ADDENDUM NO. 1

Date: April 26, 2019

PROJECT: Paving, Drainage, Illumination, and Appurtenances to serve
Santa Fe Junior High School and Cowan Administration Building
Parking Lots Rehabilitation
Santa Fe, Galveston County, Texas

1. Delete plan sheets 9 – 14 in their entirety and replace with the attached.

DRAINAGE PLAN

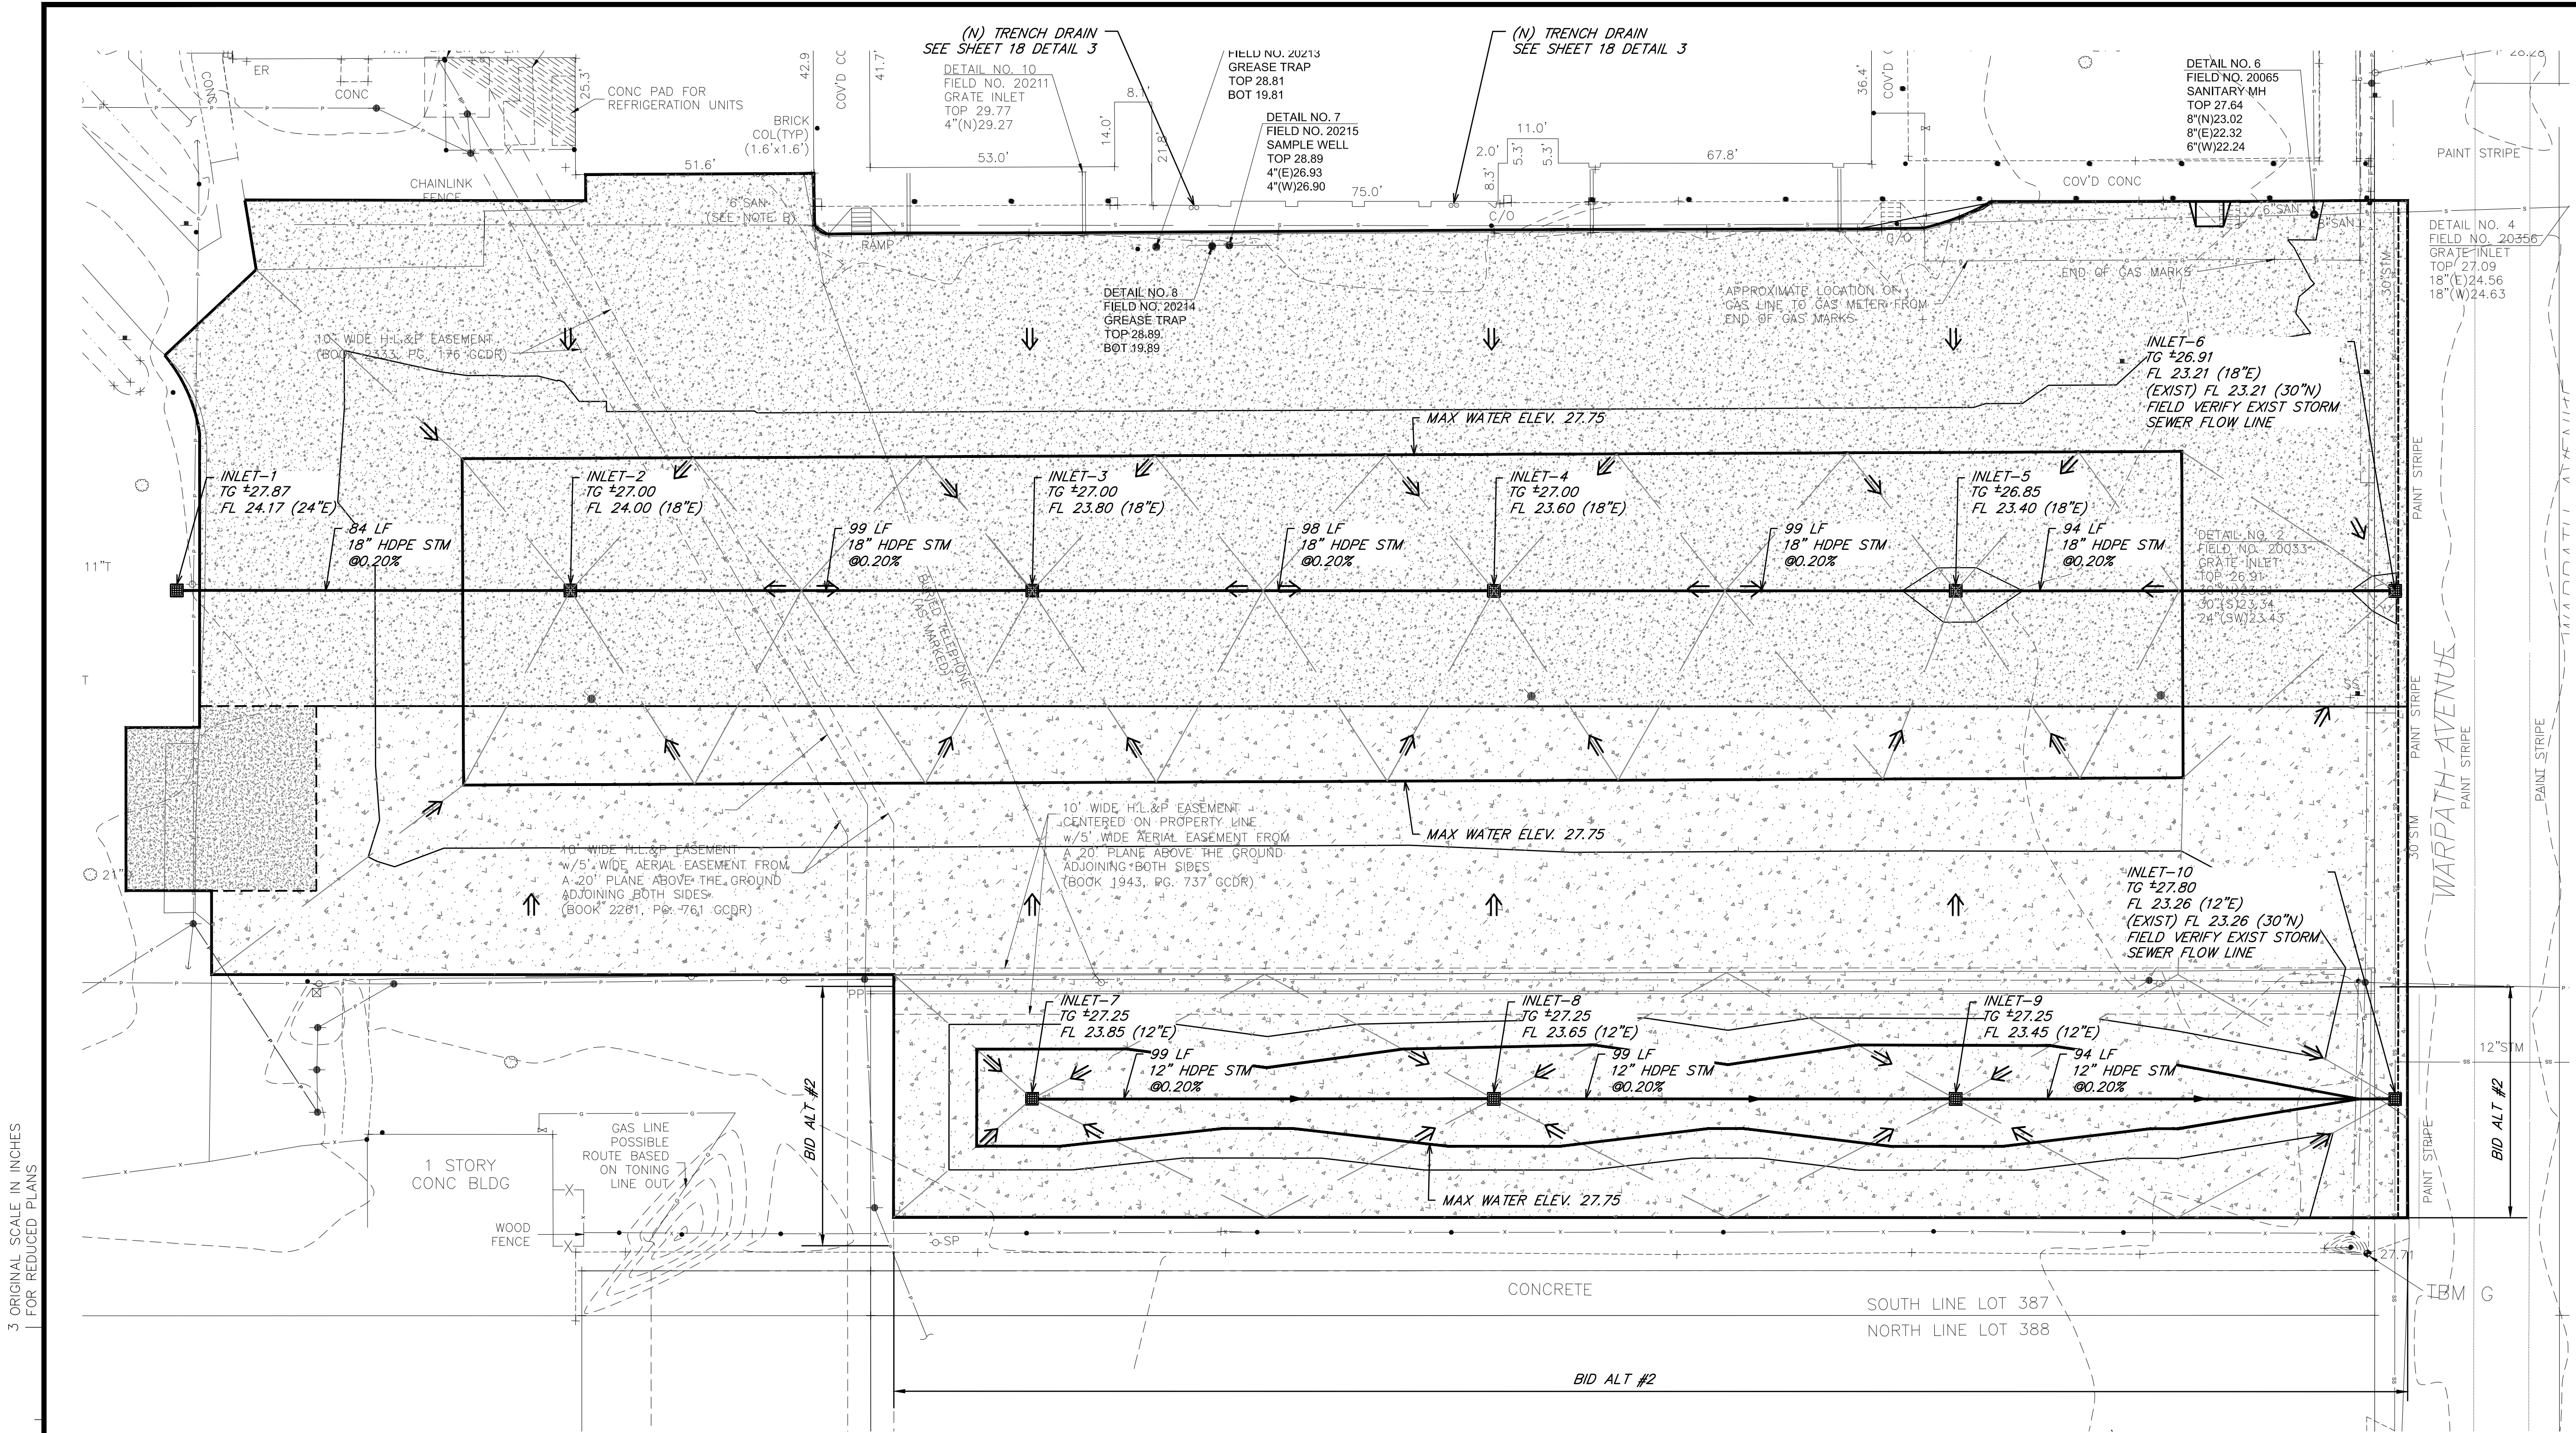
1	04/26/19	DELETED TRENCH DRAINS & ADDED BID ALT # 2 NOTE	LEK
No.	Date	Revisions	App.

STORM WATER POLLUTION PREVENTION PLAN

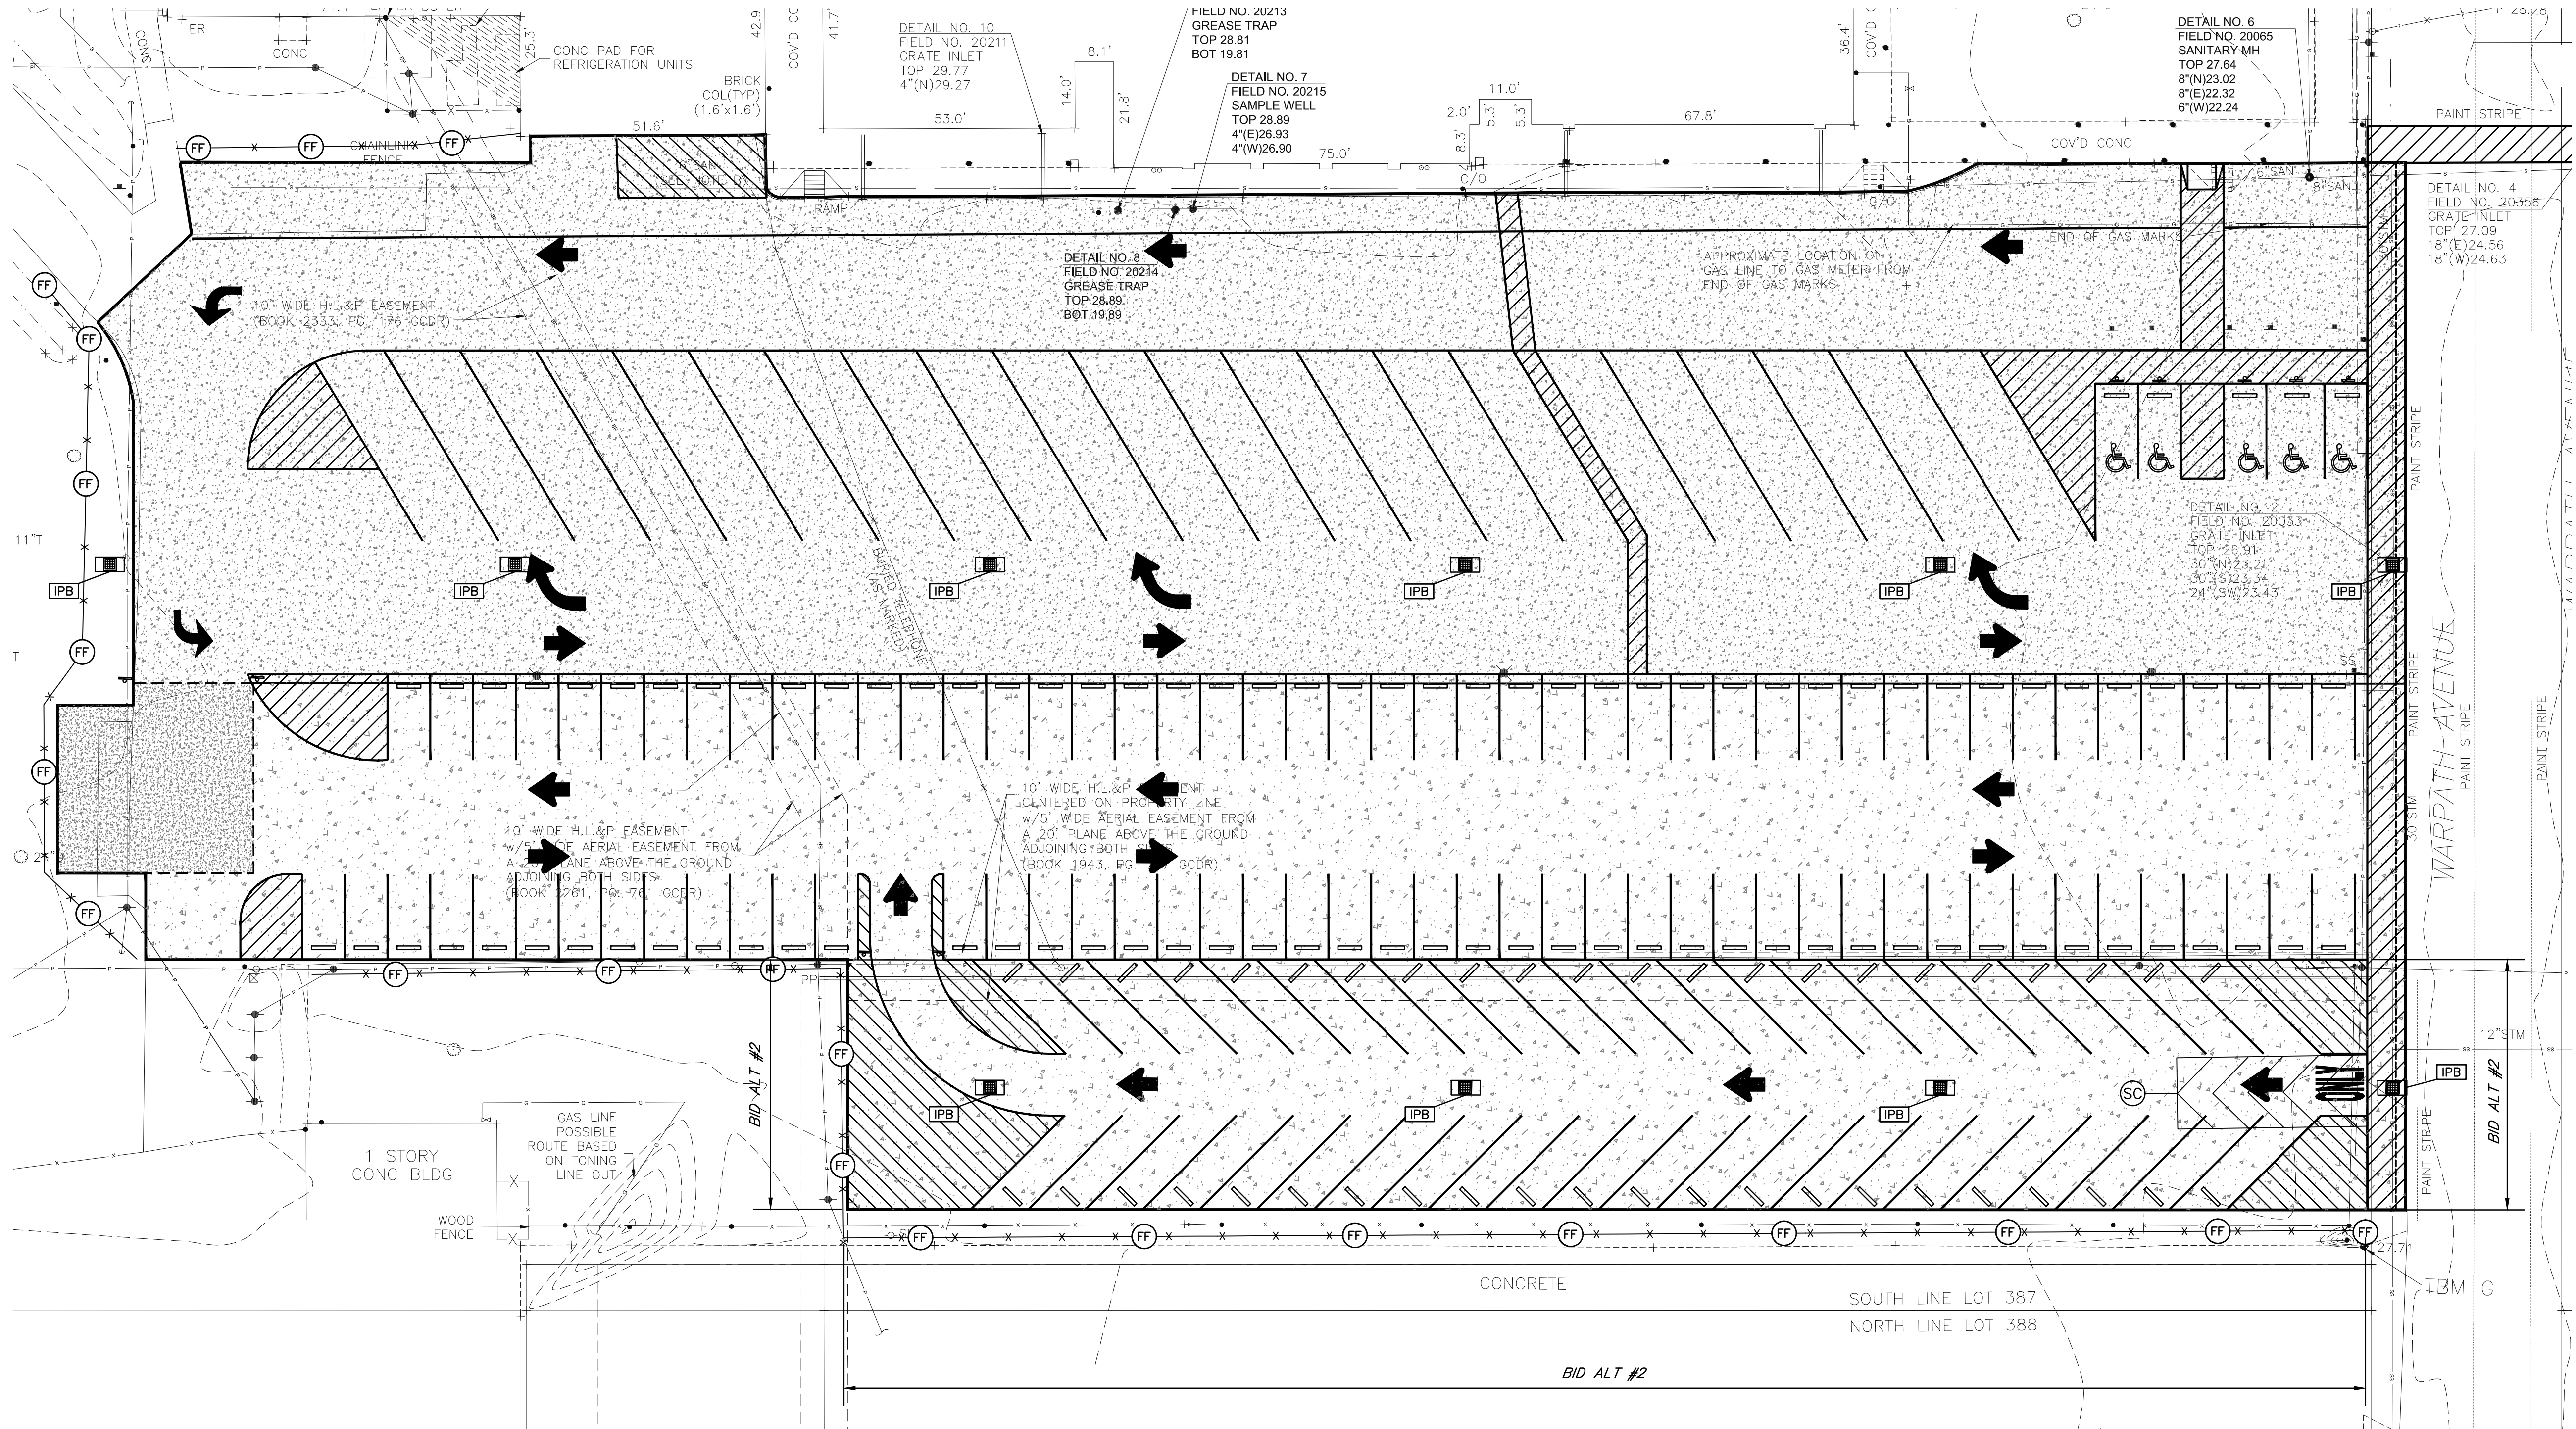
1 04/26/19 DELETED TRENCH DRAINS & ADDED BID ALT #2 NOTE LEK
